Piper Aircraft Corporation
2926 Piper Drive
Vero Beach, Florida, U.S.A. 32960

SERVICE *No. 967* BULLETIN

DATE: January 24, 1994

Aileron Hinge Inspection and Replacement

SKETCH A

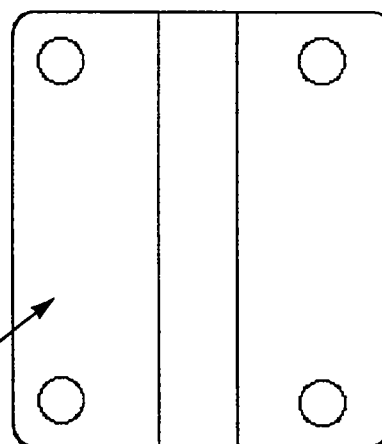
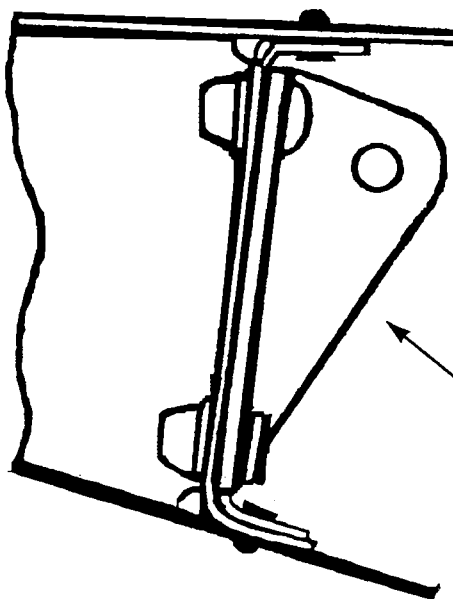
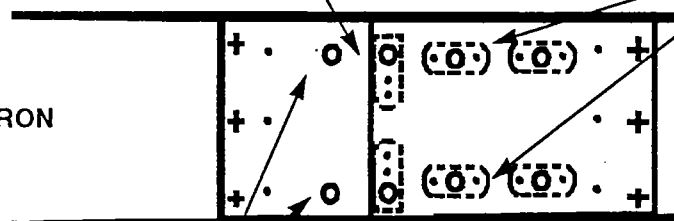
INSPECT:
CRACKS WILL
APPEAR ALONG
SPAR FLANGE
AND AT ATTACH
HOLES.

ADD HOLES & NUTPLATES

EXISTING HINGE HOLES

INSPECT:
CRACKS WILL
APPEAR ALONG
SPAR FLANGE
AND AT ATTACH
HOLES.

INSTALL NEW HINGE
P/N'S 74461-02 (LEFT)
AND 74461-03 (RIGHT)
